Answer to Bluetooth V770, FCC ID: IHDT6FJ1

High Band Edge with Hopping Disabled

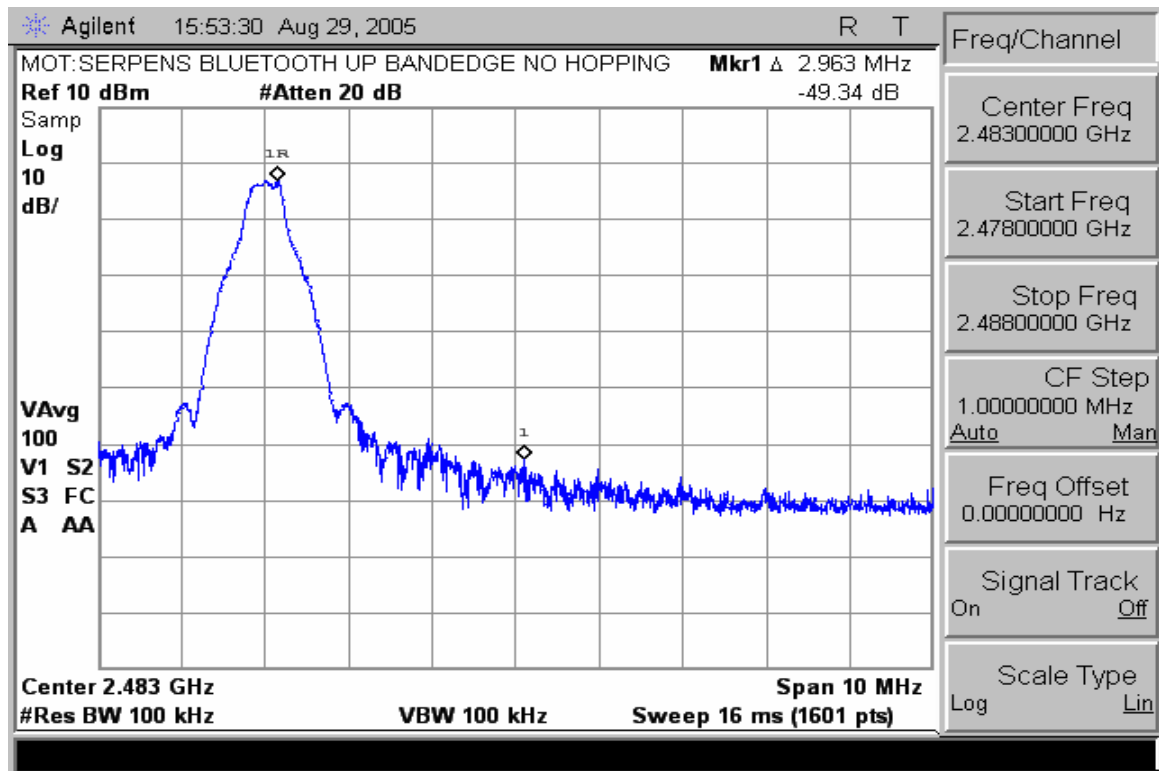
1. Page 42 of the Bluetooth Test Report shows an incorrect plot for “High Bandedge with Hopping Disabled”. Please submit the correct plot.

Response:
